REVISIONS		
No.	Remarks	Date
0	Initial submittal

<b>HIGHWAY SAFETY CORP.</b> GLASTONBURY, CT	
TRI-CHORD SIGN STRUCTURE STATE OF VERMONT COUNTY OF CALEDONIA INTERSTATE RTE. 91 STA.128.70 SB PROJECT No. AC IM 091-2(73)	DRAWN: MHM CHECKED: P. Radice DATE: 3/23/07 SCALE: NTS PROJ. REVISION NO.: 1587a GENERAL CONTRACTOR: F.R. LAFAYETTE SHEET NO.: 3 of 8

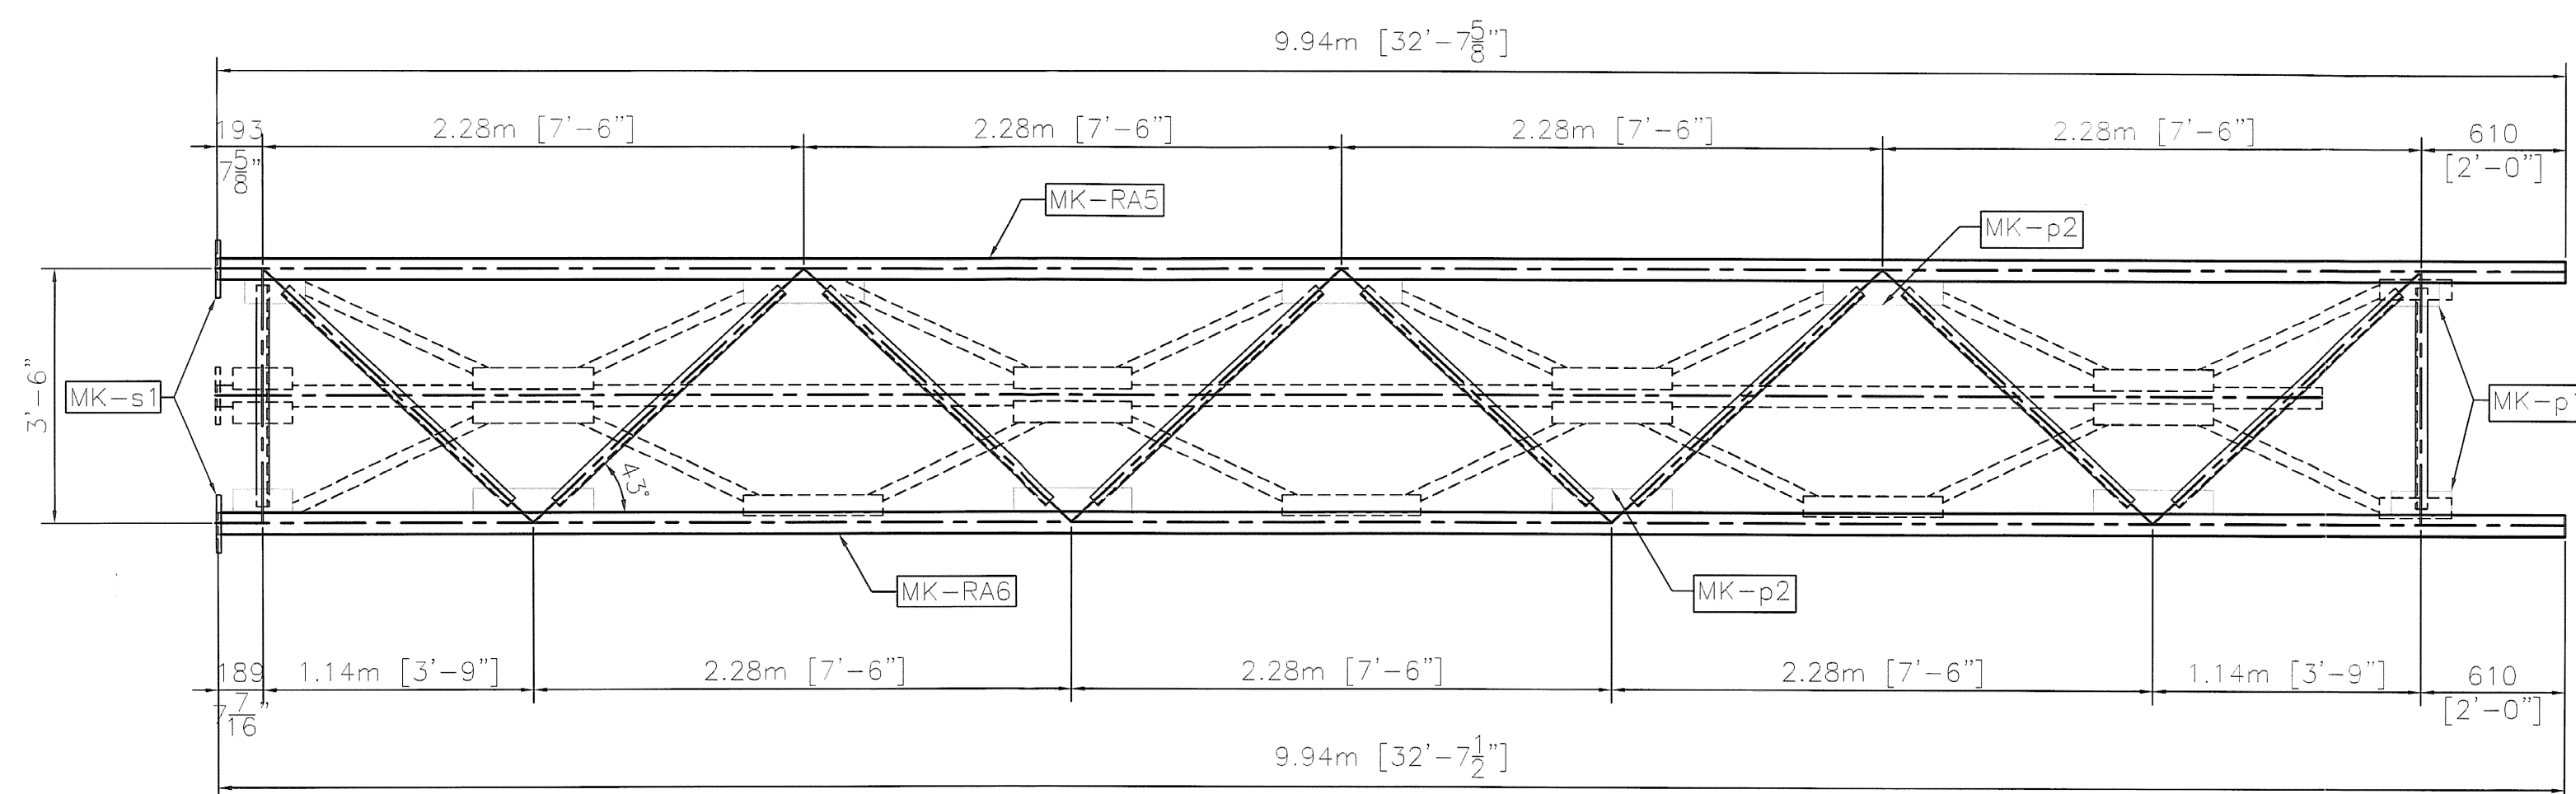
- UNLESS OTHERWISE NOTED, ALL BOLTS FOR STRUCTURAL CONNECTIONS SHALL BE M164 TYPE 1 (A325). *ASTM GR B HAS Fy 36KSI*
  - GALVANIZED U-BOLTS FOR CONNECTION OF SIGN HANGER BEAMS TO TRUSS SHALL BE ASTM F-1554 GR. 36.

- BOLTS INSTALLED IN STRUCTURAL CONNECTIONS SHALL BE PROVIDED AND TENSIONED PER APPLICABLE PROVISIONS OF STANDARD SPECIFICATIONS SECTION 506. *VDOT VAOT*

*GLC RLT  
AS NOTED  
06/14/07*
